RE: **VTT-71232-SL**

Address: 14701-14719 West Plummer Street  
Mission Hills - Panorama City - North Hills  
Planning Area

**EXTENSION OF TIME**

RE: Vesting Tentative Tract Map No. 71232-SL  
Related Case: CPC-2016-1168-GPA-ZC-BL  
Address(s): 14701-14719 West Plummer  
Street  
Mission Hills – Panorama City – North Hills  
Planning Area  
Zone : RA-1  
D. M. : 198B149; 201B149  
C. D. : 6  
CEQA : ENV-2016-1169-MND

# LOT & EASEMENT DETAIL

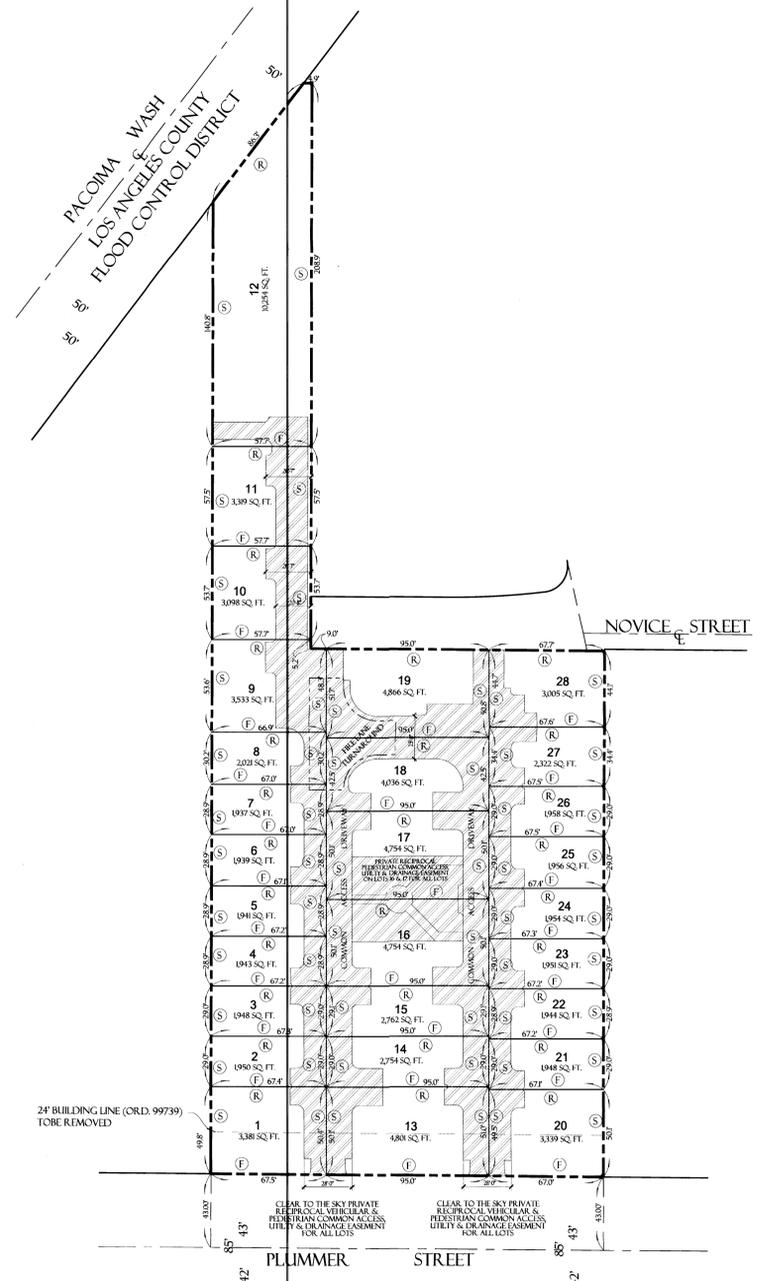
- c. Lots 19 and 28 do not comply with the minimum 15 ft. front yard setback along Novice Street after required street dedication is taken as required for the Proposed **(T)(Q)RD3-1** Zone. Revise the Map to show compliance with the above requirement or obtain approval from the Department of City Planning for the setbacks indicated in the Setback Matrix.

- d. Lots 1, 13 and 20 shall comply with 24 ft. Building Line or obtain City Planning approval for removal of 24 ft. Building Line prior to obtaining Zoning clearance.

- g. Provide and dimension the reciprocal private easement for pedestrian and driveway egress and ingress in the final map.
